THE LOCALE SUBDIVISION

Engineering Comments: FINAL PLAT COMMENTS (should be addressed prior to submitting the FINAL PLAT for review and/or signature by the City Engineer):

APPLICATION NUMBER 5 DATE September 16, 2021
APPLICANT The Locale Subdivision
REQUEST Subdivision

DETAIL SITE PLAN

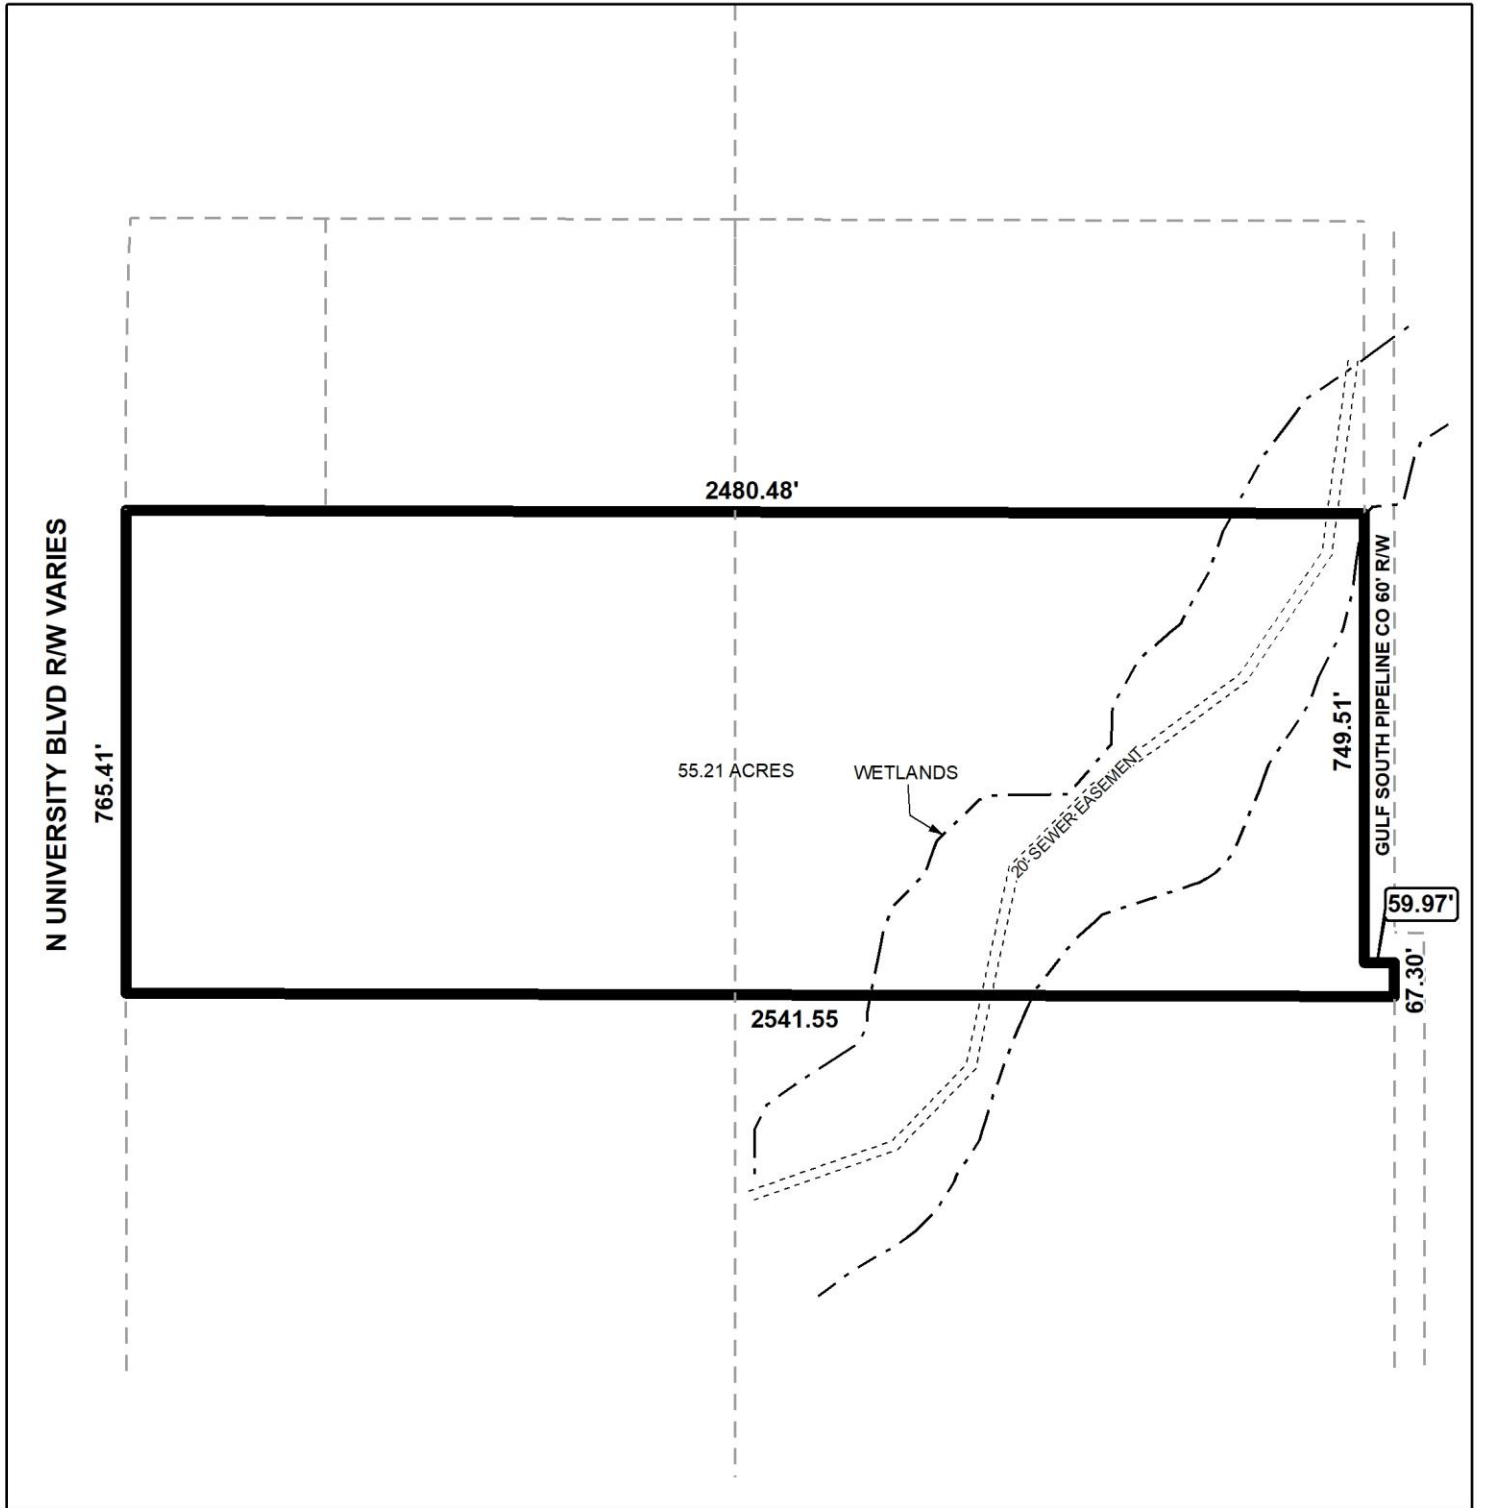
- A. Provide all of the required information on the SUBDIVISION PLAT (i.e. signature blocks, signatures, certification statements, written legal description, required notes, legend, scale, bearings and distances) that is required by the current Alabama State Board of Licensure for Professional Engineers and Land Surveyors.

- B. Provide and label the monument set or found at each subdivision corner. Verify which are “found” and which are “set”.
- C. Add legible street names on the Plat – University Blvd. or Highpoint Rd.?

- D. Correct the spelling of the street names in the vicinity map.
- E. Review and revise the written legal description and/or boundary labels to match each other.

- F. Revise the plat to label the proposed LOT (i.e. LOT 1, LOT A).
- G. National Wetlands Inventory (NWI) mapping, as shown on City of Mobile GIS information, indicates that there is potential for wetlands within the property or properties shown on this plat. Show and label the delineated wetlands, or provide a note stating that the wetlands shown on this plat are scaled from the NWI data and have not been delineated.

- H. Provide a note that a 25' riparian buffer may be required, during development, along the edge of anything considered by ADEM to be a water of the state.

- I. Provide the Owner's (notarized) signatures.
- J. Add a note to the SUBDIVISION PLAT stating that as shown on the 1984 aerial photo LOT 1 will receive historical credit of existing (1984) impervious area towards stormwater detention requirement per Mobile City Code, Chapter 17, Storm Water Management and Flood Control) as follows: LOT 1 – NONE.

The site has frontage on North University Boulevard, a component of the Major Street Plan with a planned 100-foot right-of-way along the site frontage. The preliminary plat indicates a current variable right-of-way width along the site frontage; therefore, the plat should either be revised to indicate a current right-of-way width of at least 50 feet from the centerline, or dedication should be required to provide 50 feet from the centerline of North University Boulevard.

No minimum building setback line is indicated along North University Boulevard. The plat should be revised to indicate a 25-foot minimum building setback line along North University Boulevard as measured from any required frontage dedication. The proposed lot meets the minimum size requirements of the Subdivision Regulations. The plat should be revised to label the lot with its size in both square feet and acres, revised for any required dedication, or a table should be furnished on the Final Plat providing the same information.

The plat indicates a 20-foot sanitary sewer easement meandering within the Eastern portion of the proposed lot. A note should be required on the Final Plat stating that no structure may be constructed or placed within any easement without the permission of the easement holder. The plat also indicates a 60-foot Gulf South Pipeline Company right-of-way adjacent to the East side of the site. A note should be required on the Final Plat stating that access to this right-of-way is denied.

- 1) revision of the plat to indicate a current right-of-way width of at least 50 feet from the centerline of North University Boulevard, or dedication to provide 50 feet from the centerline of North University Boulevard;

- 2) revision of the plat to indicate a 25-foot minimum building setback line along North University Boulevard as measured from any required frontage dedication;

- 3) revision of the plat to label the lot with its size in both square feet and acres, revised for any required dedication, or the furnishing of a table on the Final Plat providing the same information;

- 4) placement of a note on the Final Plat stating that no structure may be constructed or placed within any easement without the permission of the easement holder;

- 5) placement of a note on the Final Plat stating that access to the Gulf South Pipeline Company right-of-way is denied;
- 6) compliance with the Engineering comments: (*FINAL PLAT COMMENTS (should be addressed prior to submitting the FINAL PLAT for review and/or signature by the City Engineer): A. Provide all of the required information on the SUBDIVISION PLAT (i.e., signature blocks, signatures, certification statements, written legal description, required*
